TN ERFO FS CHRKE804 2020-2(1)

Amendment No. 0002
Project TN ERFO FS CHRKE804 2020-2(1)
Cherokee National Forest
Solicitation: 693C73-26-B-000011

The purpose of this Amendment is to:

AMENDMENT NO.2	PROJECT	SHEET NUMBER
	TN ERFO FS CHRKE804 2020-2(1)	D13

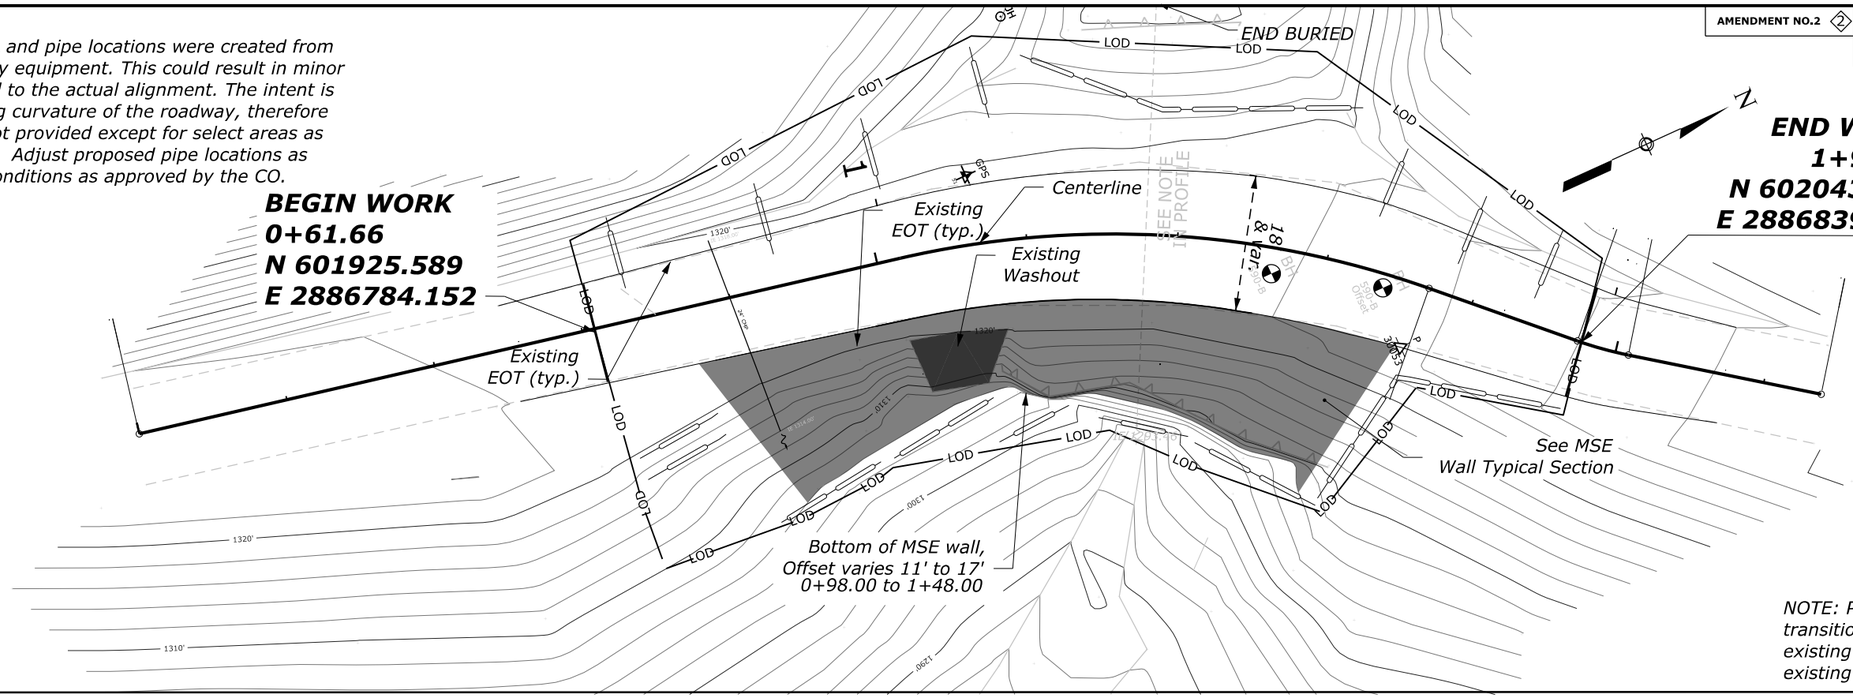
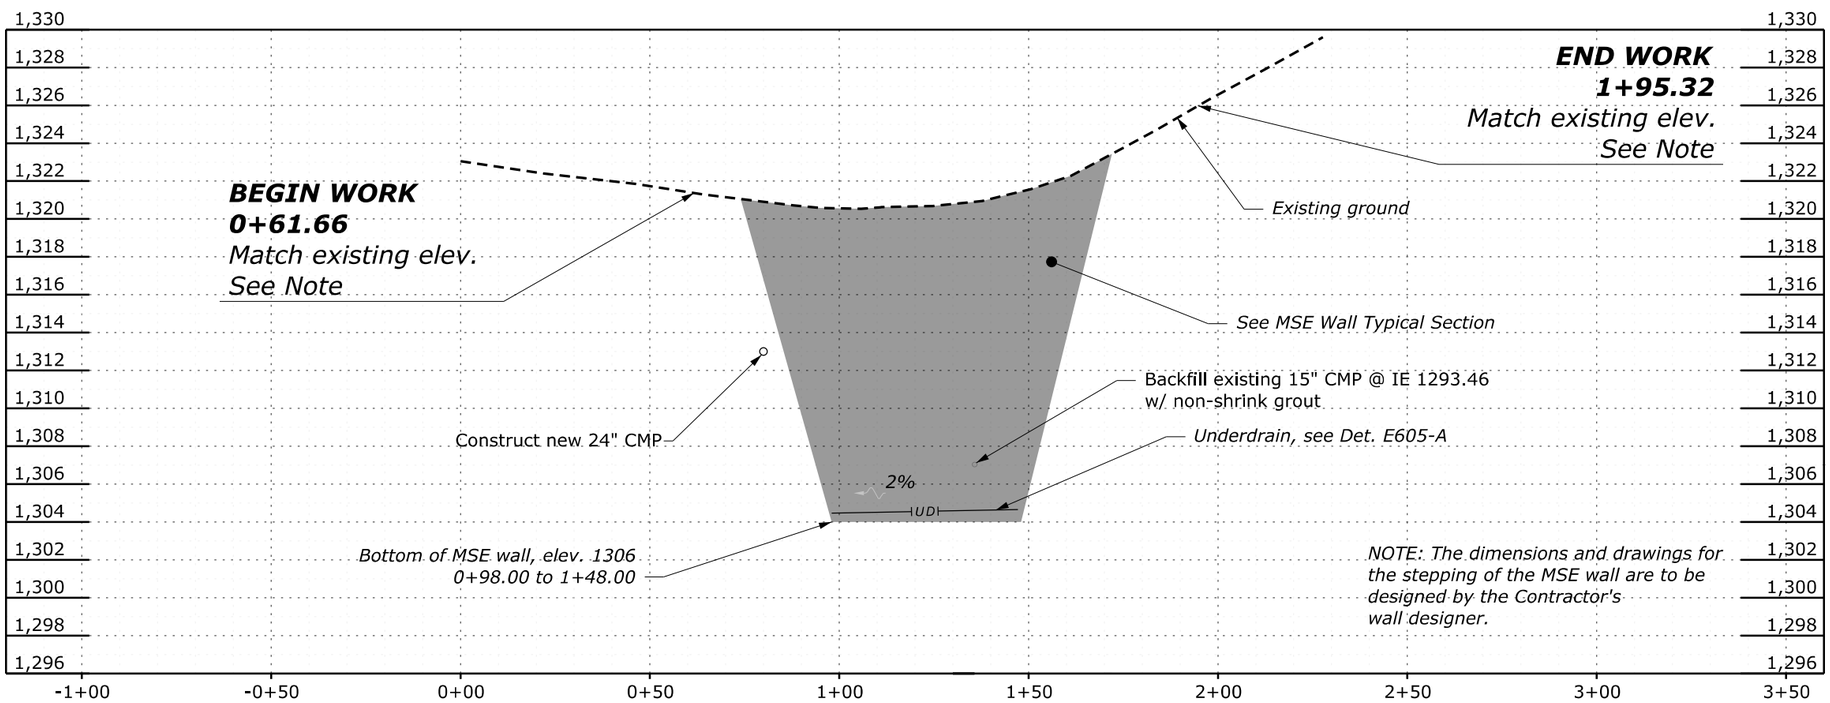
1. Sheets D13 & D14: The current scale does not fully depict the project area. **Response: The scale has been adjusted. See amended Sheets D13 and D14.**

10. Drawing D13, Paint Mountain Road, MP 4.81, shows installing a MSE Wall. This location seems to be directly over an existing drainpipe that carries a lot of water. Is the government expecting the MSE wall foundation to be above the existing large drain and go over? Or does a new culvert/box culvert etc. need to be installed at this location? If so, what size? **Response: As shown on Sheet D13, backfill the existing 15-inch CPM at invert elevation 1293.46 with non-shrink grout.**

NO.	DATE	BY	REVISIONS
2	06/15/26	JMF	AMD #2 - Updated viewport area.

AMENDMENT NO.2 2	PROJECT	SHEET NUMBER
	TN ERFO FS CHRKE804 2020-2(1)	D14

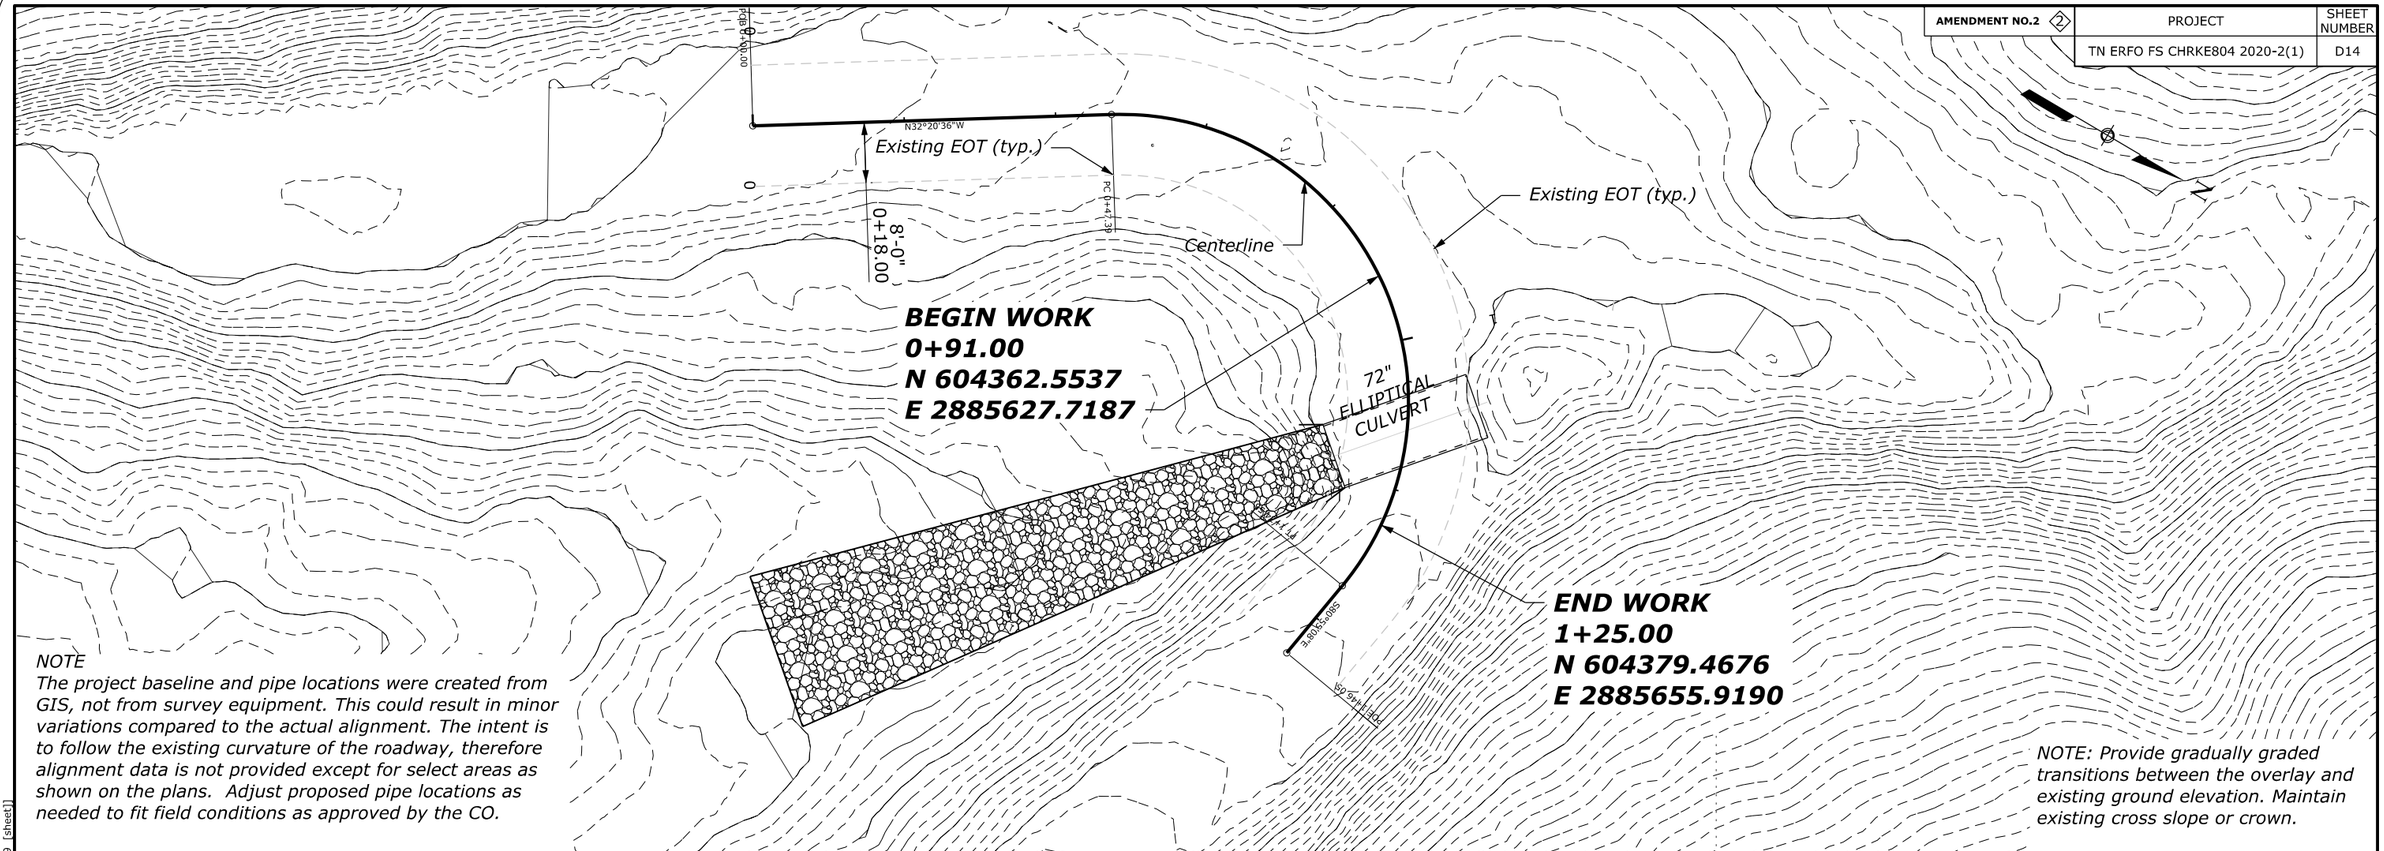
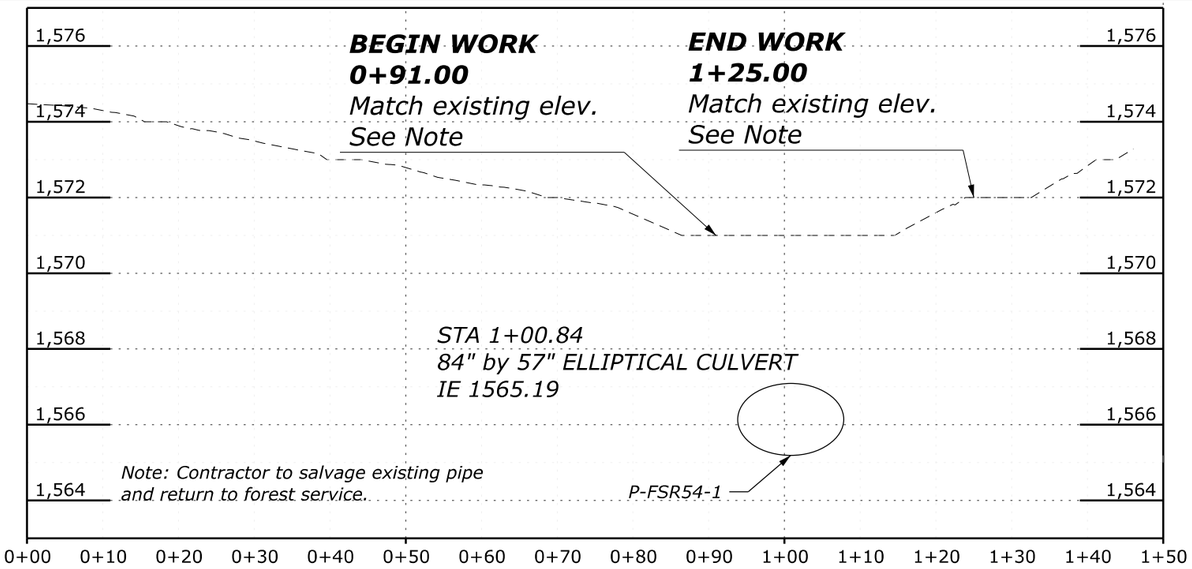
2. Sheet D14 (Station +8): The schedules on Sheet C08 indicate 5 cubic yards of Class 2 riprap at Station +8. However, Sheet D14 does not show any work at this location that would require riprap. **Response: The Sheet reference on Sheet C08 has been corrected. See amended Sheet C08.**

3. Sheet D14 (Station 1+01): The schedule lists 151 cubic yards of Class 4 riprap here. I assume this is for the elliptical culvert outfall, but the drawing does not show the extent of the placement **Response: The scale has been adjusted. See amended Sheet D14.**

NO.	DATE	BY	REVISIONS
2	06/15/26	JMF	AMD #2 - Updated viewport area.

AMENDMENT NO.2	PROJECT	SHEET NUMBER
	TN ERFO FS CHRKE804 2020-2(1)	M13

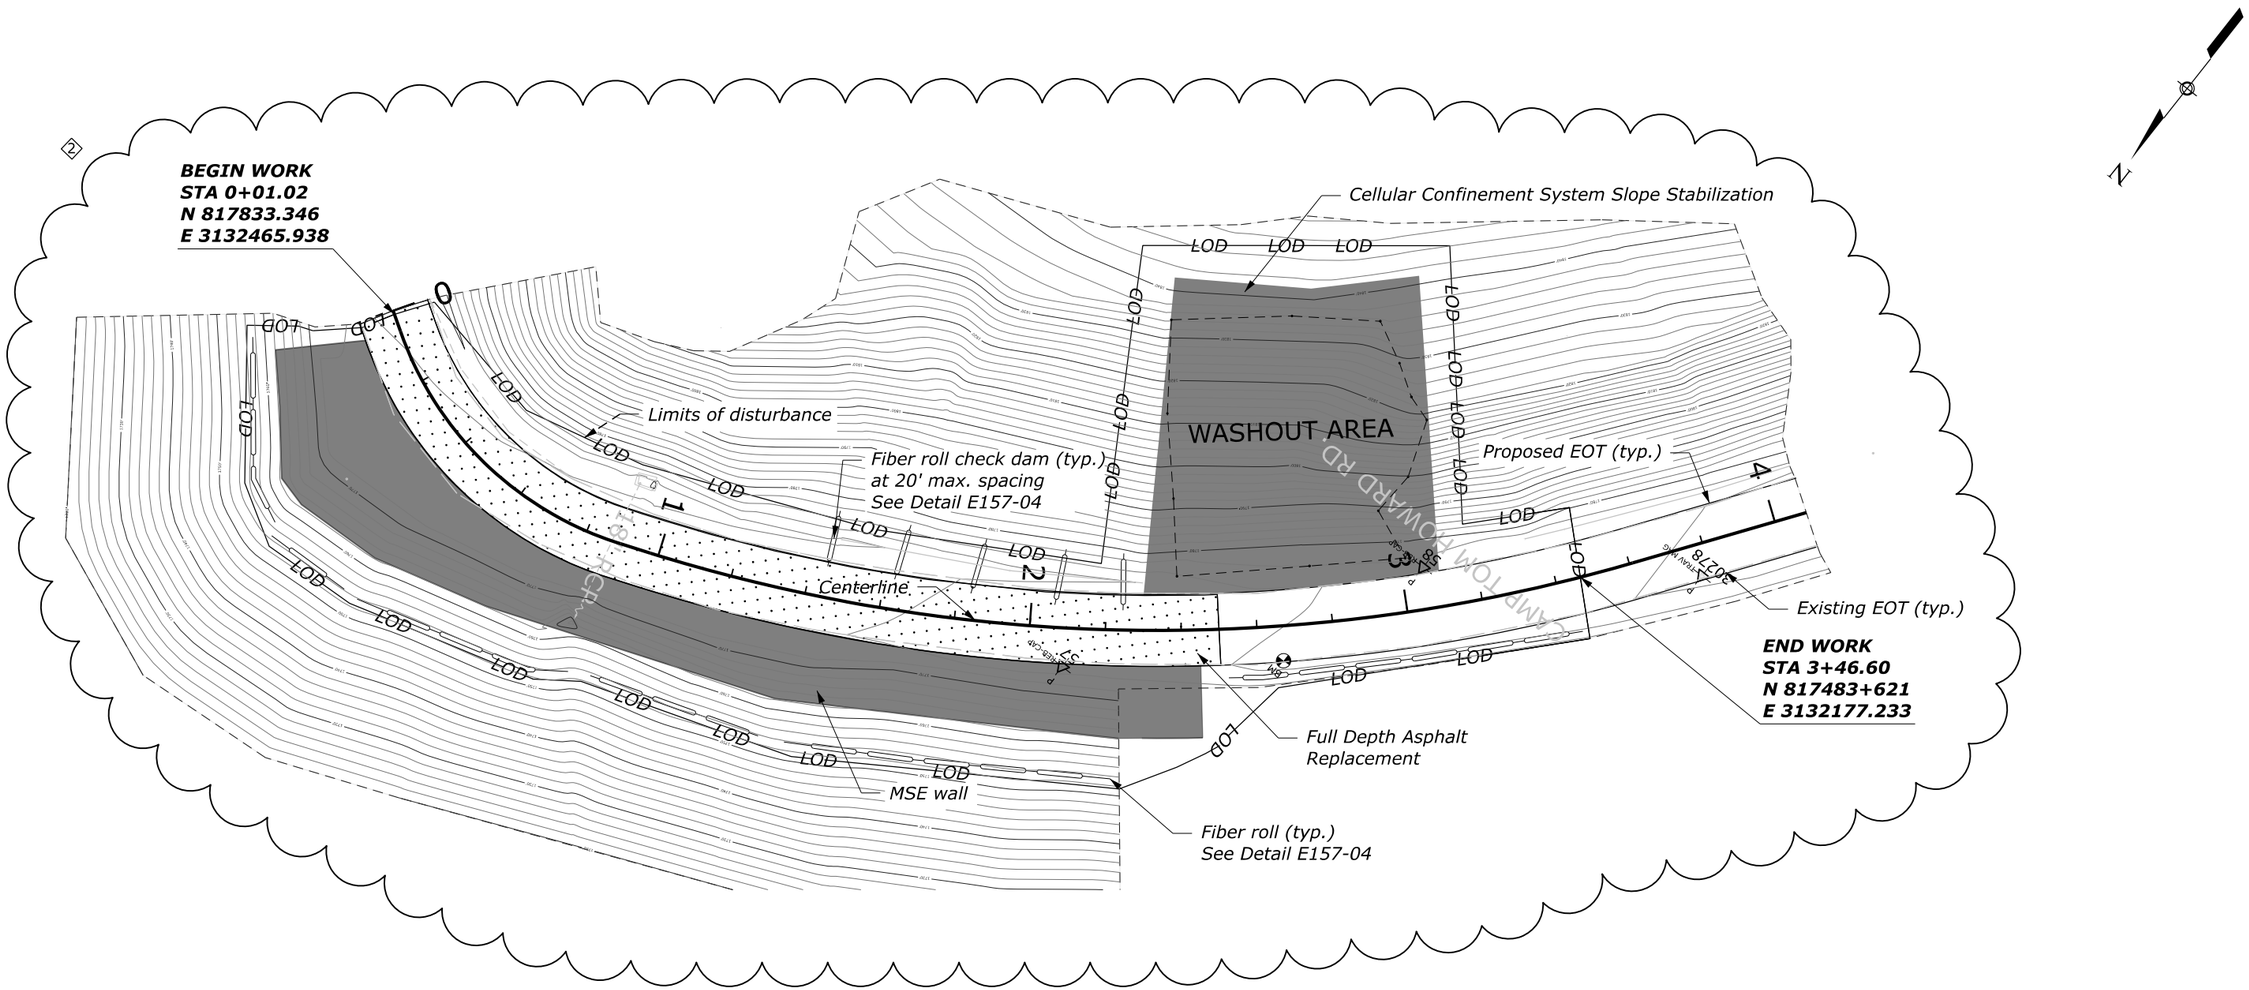
9. Drawing M13, Flatwoods Road, MP 5.78, shows installing a Cellular Confinement System for Slope Stabilization. This drawing also outlines the LOD (limits of disturbance). Drawing B03 shows a typical section for the Cellular Confinement System, which shows the top section turned under, and what we assume is buried once trenched in the ground. The LOD doesn't allow enough room to allow this to happen. Are we allowed to clear additional to make this work? If so, how far back are we allowed to clear back? Also, the grade is too steep to access equipment. Will the contractor be allowed to gain access from another location that is safer to gain access to the top of the cellular construction area? **Response: Sheet B03 has been updated to provide the dimensions for the limits of disturbance. Additional access points must be approved by the CO prior to bringing work.**

NO.	DATE	BY	REVISIONS
2	06/15/26	JMF	AMD #2 - Added hatching for asphalt and label.
